Work Order ID 137892

Item ID: D350-607-541 Accept *N900040100* Setup Start *NS1*
 Revision ID:
 Item Name: Quick Release Heli-Utility-Basket™ Long, HD Lid, Spacepod™/Squirrel Cheek Comp. Stop *NS2*
 Start Date: 11/10/2015 Start Qty: 1.00 *1* Cust Item ID:
 Required Date: 11/20/2015 Req'd Qty: 1.00 *1* Customer:
 Reference:

DART SERVICE INSTRUCTION

TO AMEND INSTALLATION INSTRUCTIONS D350-607-3 Rev.D,
INSTALLATION INSTRUCTIONS D350-607-4 Rev. C AND
INSTRUCTIONS FOR CONTINUED AIRWORTHINESS ICA-D350-607 REV. 6
REF TCCA STC: SH94-14
REF FAA STC: SR00213NY
REF EASA STC: EASA.10016996
REF BRAZILIAN STC: 2007S03-03/-04/-05/-06

FIGURE 1: INSTALLATION OF D4775-041 FWD STRUT

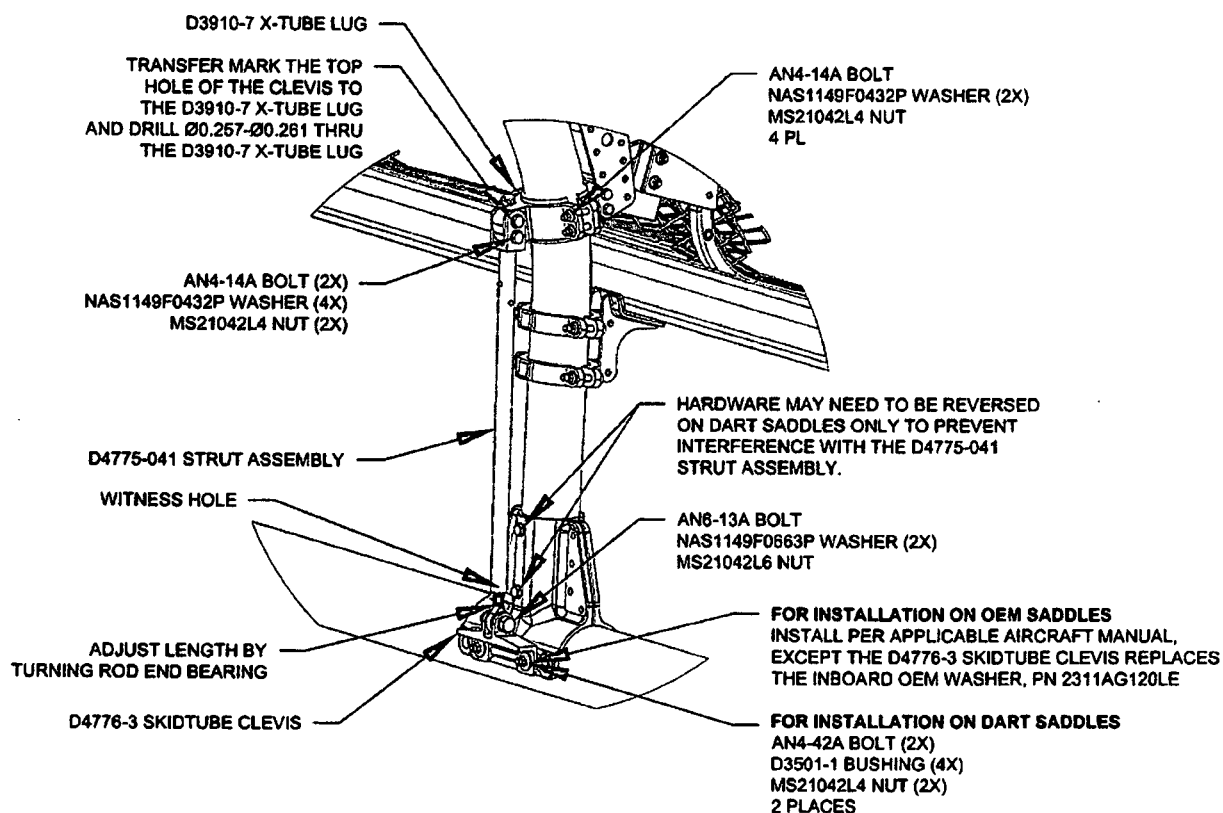
- 3.1 Substitute the Forward Lower D3910-5 X-Tube Lug with the D3910-7 X-Tube Lug as shown in Figure 1.
- 3.2 Install the forward D4775-041 Strut Assembly. Transfer mark from the upper hole on the clevis of the D4775-041 Strut Assembly to the D3910-7 X-tube Lug and drill thru the lug $\varnothing 0.257$ - $\varnothing 0.261$ as shown in Figure 1. Touch up chemical conversion coating per MIL-DTL-5541. Check the witness holes located at the bottom end of the D4775-041 Strut Assemblies to ensure that the thread from the rod end extends past the witness hole.
Torque MS21042L4/-4 nuts to 50-70 in-lbs (5.7-7.9 N-m). Torque MS21042L6/-6 nuts to 160-190 in-lbs (18.1-21.5 N-m).
- 3.3 Complete the installation in accordance with Installation Instructions D350-607-3 Rev. D or D350-607-4 Rev. C.
